UNITED STATES
DEPARTMENT OF THE INTERIOR
BUREAU OF LAND MANAGEMENT

SUNDRY NOTICES AND REPORTS ON WELLS
Do not use this form for proposals to drill or to re-enter an abandoned well Use form 3160-3 (APD) for such proposals.

LINN OPERATING, LLC IS RESPECTFULLY SUBMITTING A PROPOSED PLUG AND ABANDONMENT PROCEDURE FOR THE MCCLAY FEDERAL #10 WELL IN EDDY COUNTY, NM

McClay Federal #10
Eddy County, NM
North Benson Queen Field
API: 30-015-21674

LEASE & WELL NO **McClay Federal #10**
 LOCATION 1650' FNL, 2310' FWL of Sec 33, T-18-S, R-30-E
 FIELD North Benson Queen Field

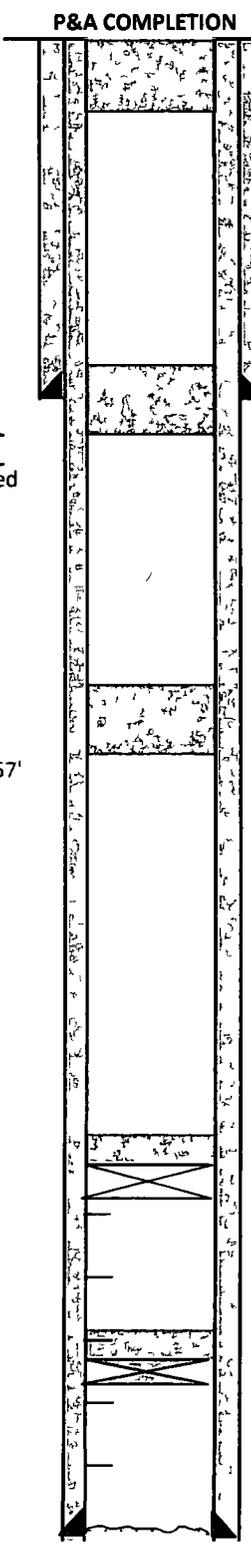
Spot 15 sx plug at 200'
 200' cement plug at 0' to 200'

Spot 15 sx plug at 590'
 200' cement plug at 390' to 590'

Spot 15 sx plug at 1700'
 200' cement plug at 1500' to 1700'

CIBP at 2800' with 4 sx of Cement

- 1 Place 4 sacks of cement on CIBP at 3169' *Dump Bail WOC Tag*
- 2 Set CIBP at 2800' and place 4 sacks of cement on CIBP *Dump Bail on spot 25 sx.*
- 3 Pressure test the casing to 500 psi
- 4 Circulate mud laden fluid to surface
- Per F 5 ~~Spot a 15 sack cement plug from 1500' to 1700'~~ *1717. SQZ cement to 1600*
- Per F 6 ~~Spot a 15 sack cement plug from 390' to 590'~~ *540. SQZ cement to 435. WOC Tag*
- Per F 7 ~~Spot a 15 sack cement plug from 0' to 200'~~ *60. SQZ cement to surf. Tag*
- 8 Cut well head off and weld on a dry hole marker

35' min. Dump Bail

25 sx min plugs.
